August 17, 2016

RE: Draft Supplemental Environmental Assessment (SEA) #5 regarding dams and spillway design refinements on the Isabella Lake Dam Safety Modification Project

Existing Spillway pdf page 251-252

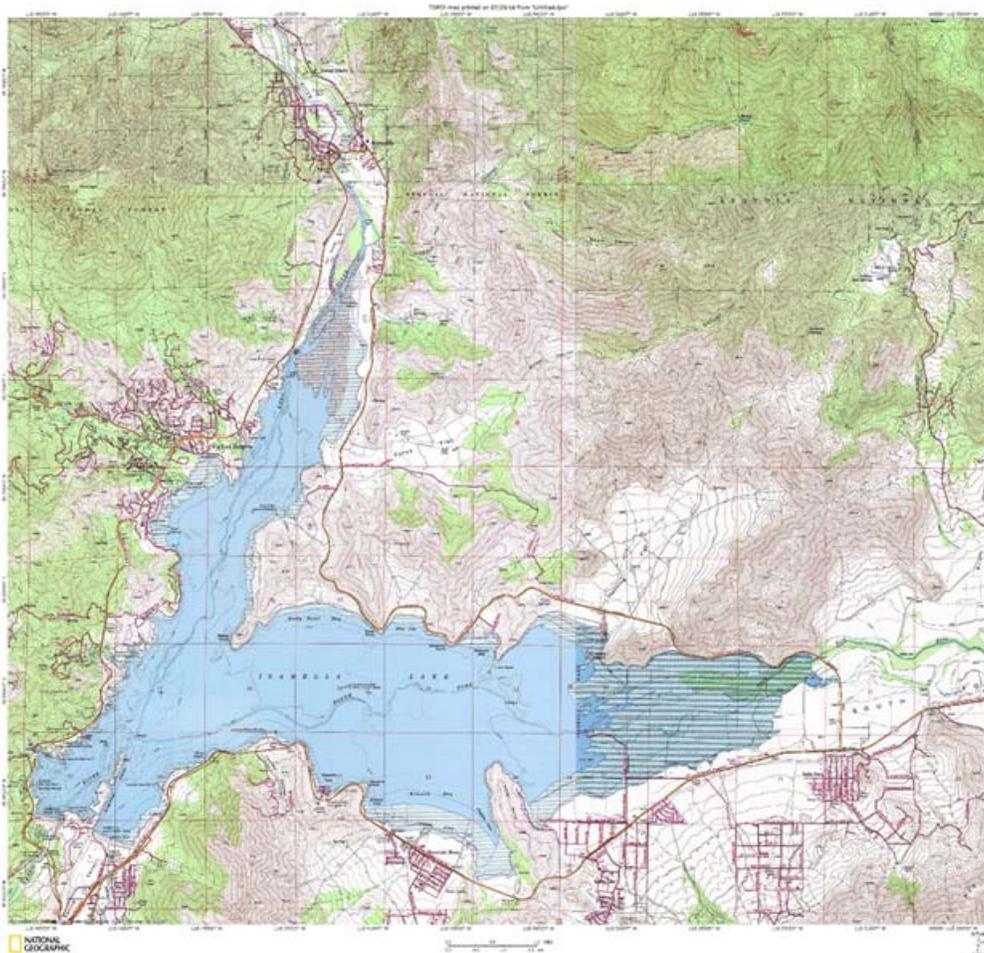
Critically, *the Corps must clarify what the proposed final height of the main spillway will be after project completion of the project.* We are troubled by the staff response to a question at the meetings of Wednesday, February 24, 2016 and Tuesday, July 26, 2016 about the height of the main spillway after project completion. Staff stated that the main spillway would rise to be level with the emergency spillway designed to be at the height of the current dam structure.

This response, that the height of the existing spillway would increase by sixteen feet at the February meeting and then twenty-eight feet at the July meeting, via the response that the height of the spillway would increase to the height "of the current dam structures" from 2,609' to 2,637' is confusing and contradicts the ROD from December 2012 which states

If true that the spillway height would be increased by either sixteen feet (16') or twenty-eight feet (28'), the Project would add millions of acre-feet of increased storage to the pool in the event of a flood and would flood all property, habitat, and infrastructure to a minimum of 2,637-feet, which is 28-feet above the current maximum pool height of 2,609-foot. However this flooding of additional property has never been analyzed; the impacts to the people and environmental resources upstream of the dam must be identified and analyzed.

Increasing the height of the spillway from the height analyzed in the FEIS is a major change that would increase the pool by orders of magnitude and threaten upstream interests. The 1 in 4,700-year flood will be more dangerous to a sizable population upstream as escape routes will be underwater and high ground inaccessible by Army Corps of Engineers design.

If the spillway remains the same height, but with the buttressed sides to match the height of the raised flanks, then the spillway would be 44' below the height of the emergency spillway, which seems to be exposing the narrowest dam segment to an extremely high pressure before the emergency spillway could protect it.

If the spillway is raised from the current spillway height of 2,609' in elevation to the current elevation of the main and auxiliary dams at 2,637' elevation, shouldn't the Corps, in its EIS, analyze the impacts to the thousands of acres of private and county property, farmlands, roadways, and airport, as well as the riparian habitat areas around the reservoir, including the Audubon Kern River Preserve, that would be flooded before water breaches the new spillway?
